Glanville Consultants Response to LLFA Comments

Cedar Cottage, Sandygate Lane, Lower Beeding, RH13 6LR

West Sussex County Council LLFA Comments 03/06/2026

RE: DC/26/0640 Cedar Cottage Sandygate Lane Lower Beeding RH13 6LR

Foul and Surface Water Drainage Strategy

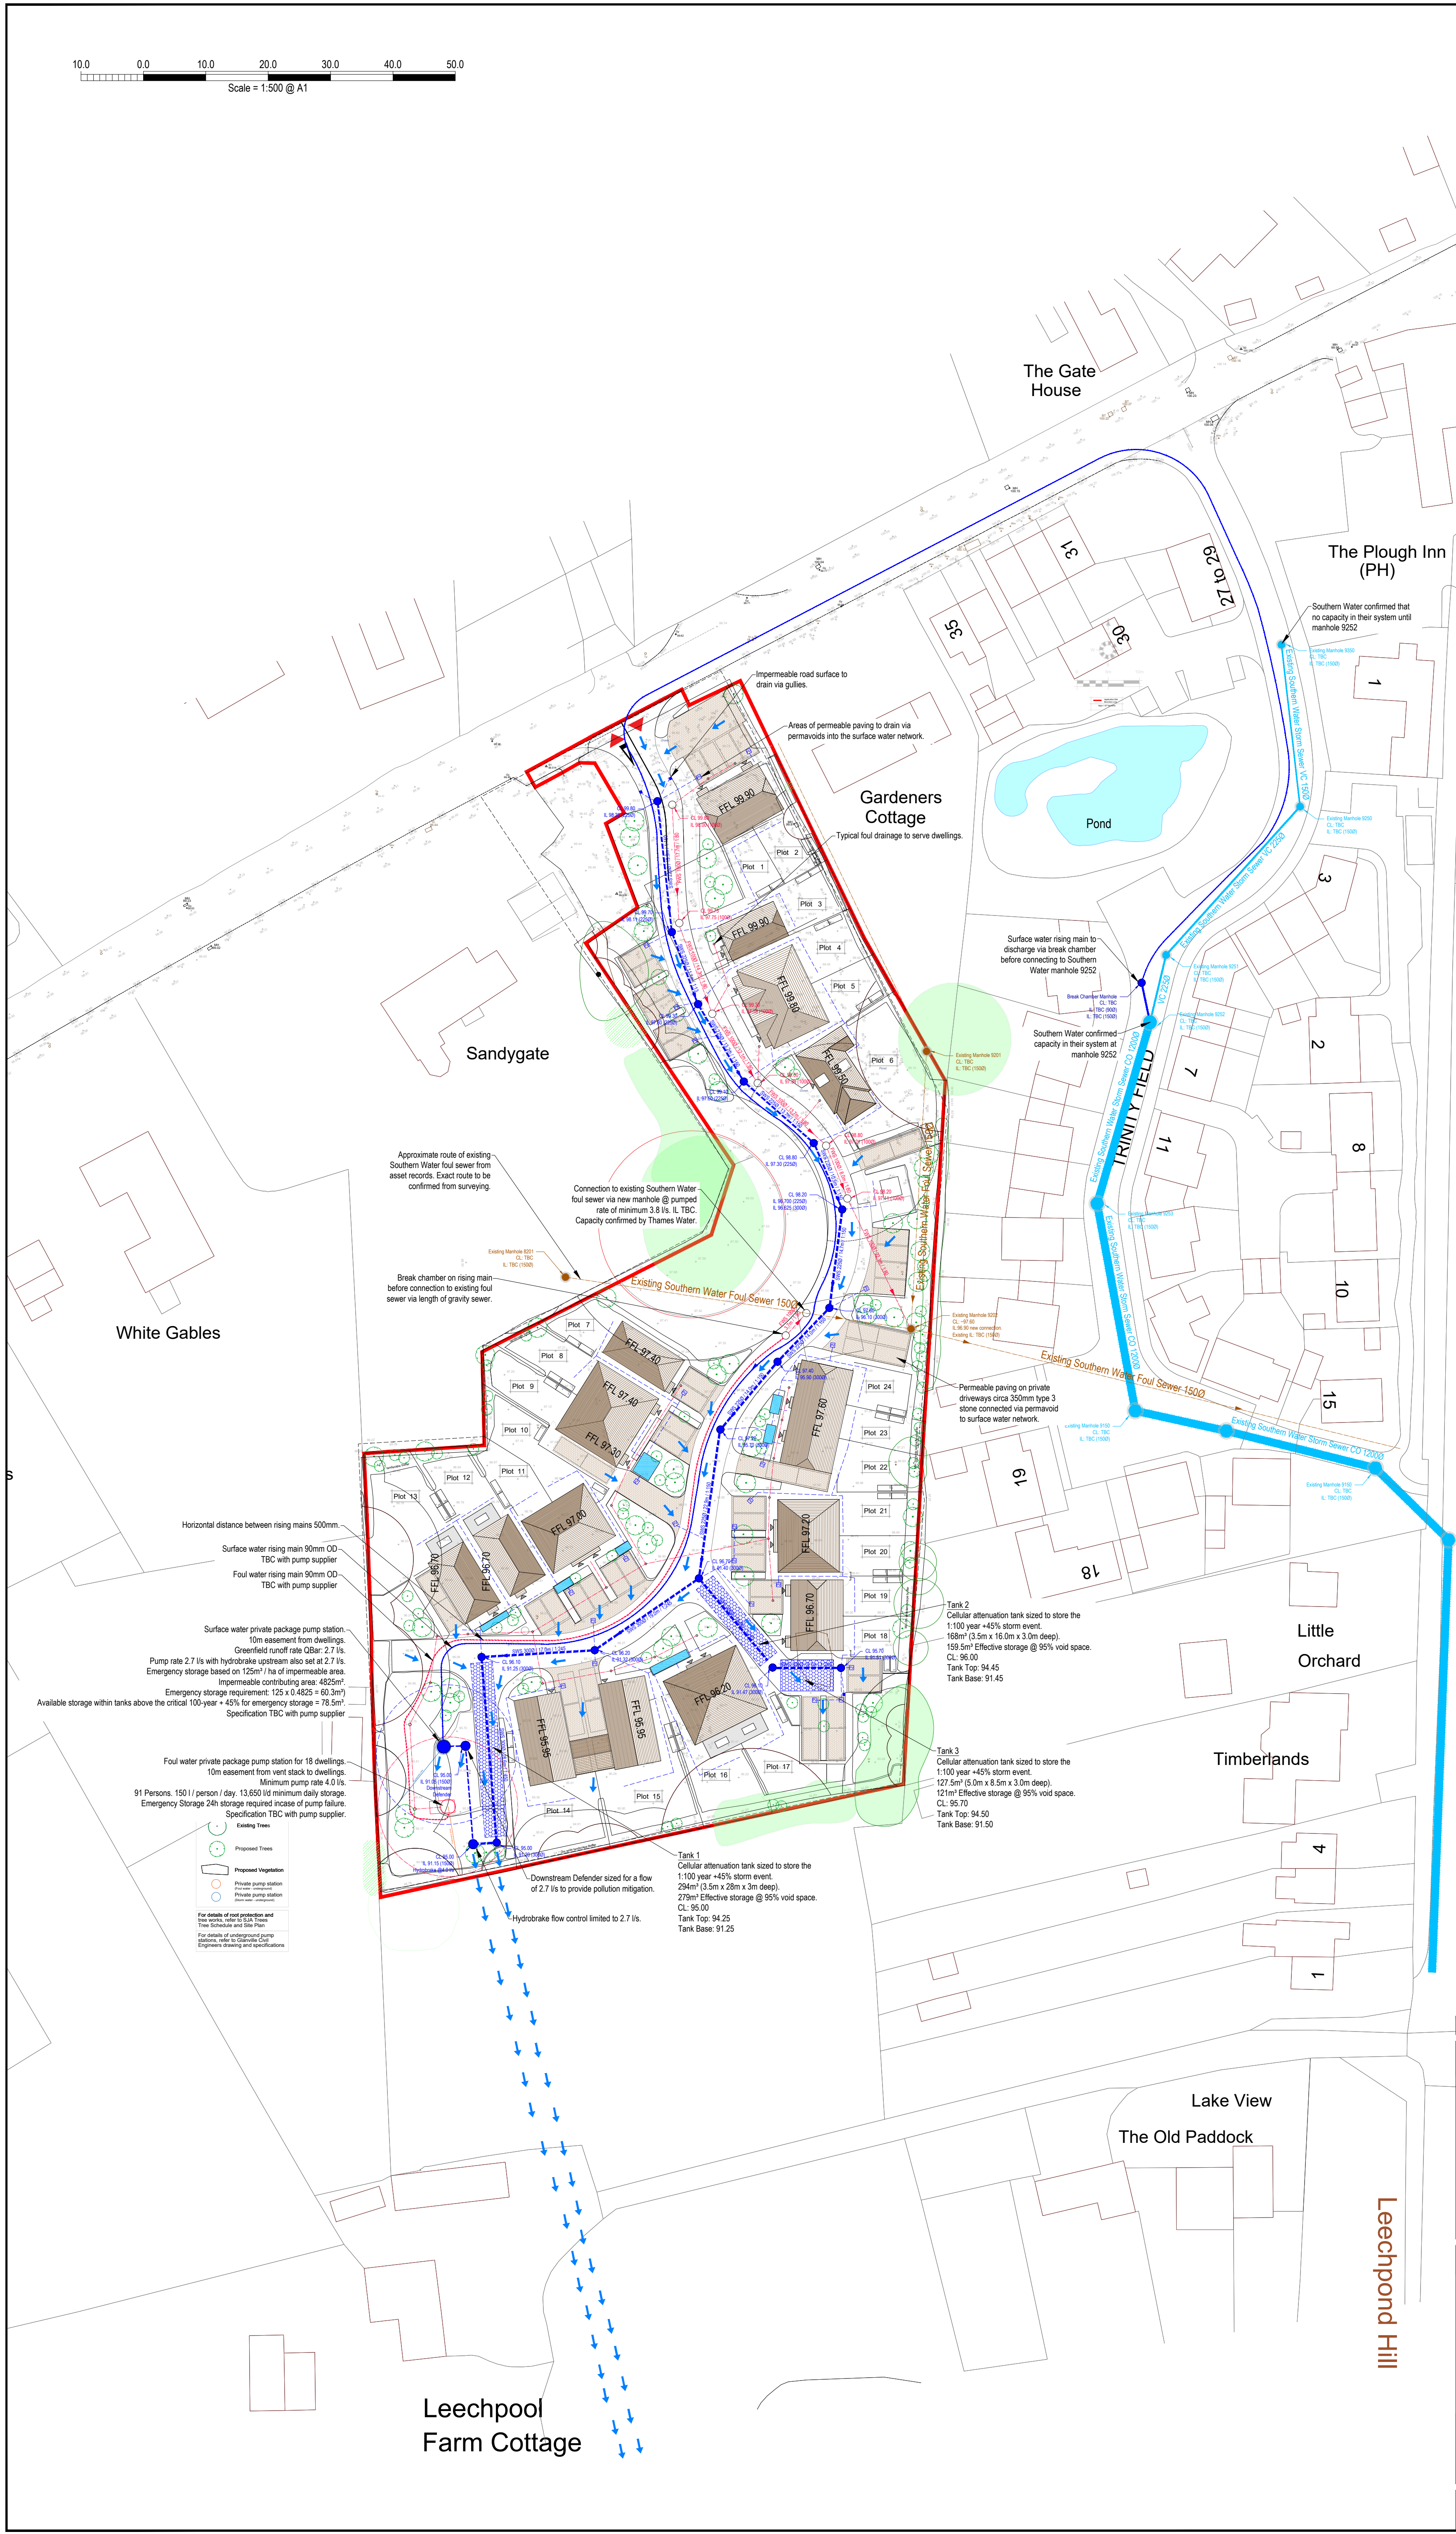
LLFA Commentary: *'A detailed management plan for pump failure, including how emergency storage capacity (up to 24hrs) is managed within the system. This is particularly critical given the proximity of the storage / pump to the southerly redline boundary, ground conditions and the proximity (or lack of) a waterbody downstream of the development, should a failure occur.'*

Glanville Response: Please see the foul and drainage strategy in appendix B for details of exceedance flow and emergency storage. Please see offsite flow plan in Appendix C for the flow path between the site and the downstream watercourse. Emergency storage for the surface water system is calculated using 125 m³ per hectare of impermeable area onsite in line with The Design and Construction Guidance (Water UK, 2021). The emergency storage requirement for the site is 60.3 m³. The available storage within the tanks above the critical 100-year + 45% to accommodate the emergency storage is 78.5 m³. The emergency storage for the foul system will be 13,650 l/day or 13.65 m³.

Land Ownership Plan

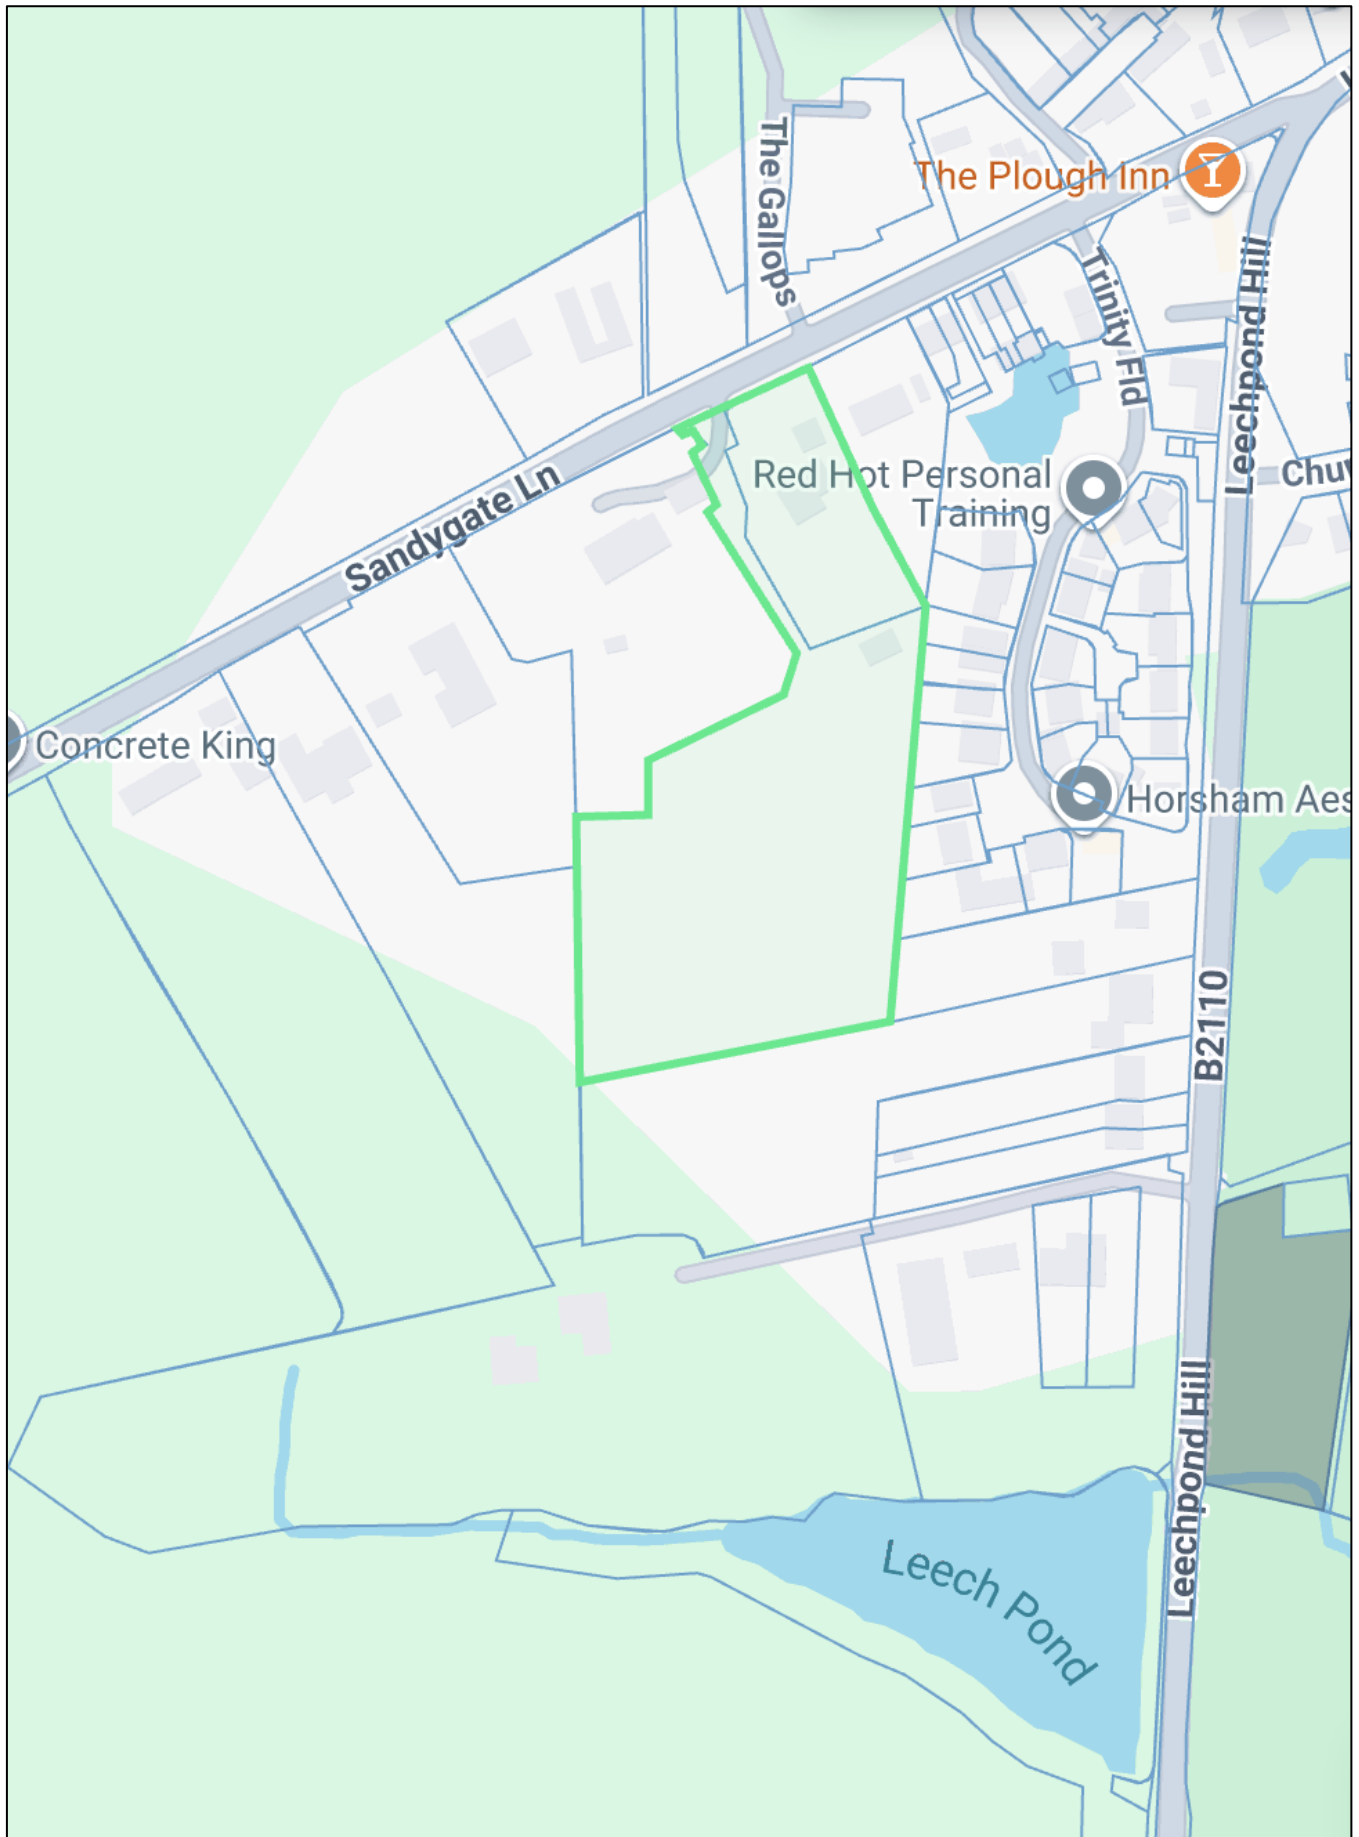
LLFA Comment: 'Pumping of surface water should only be used where there is no practicable alternative (see 1.24 of Standard 1 of the National Standards for SuDS) we require further evidence that connections to either the watercourse to the South or the Southern Water network at a more southerly location (where a full or partial gravity fed connection could be feasible) have been adequately explored and discounted in accordance with 1.3 of the above Standard.'

Glanville Response: Please see appendix D for the land registry plan which shows all land ownership boundaries for the immediate area. The plan shows the requirement for permission from three third party landowners to lay a sewer between the site and the downstream watercourse and waterbody of Leech Pond. Routes to connect to the Southern Water network at a more southerly location were also explored. As shown on the map in appendix D, there is a road that extends west from the B2110 towards the south of the site. However, this is evidently a gated private driveway, and this route would require circa 200m of sewer to be laid through three separate third party landownerships. Therefore, the surface water drainage strategy that utilises a pump station to facilitate a connection to the Southern Water network within Trinity Fields is the only practicable solution.
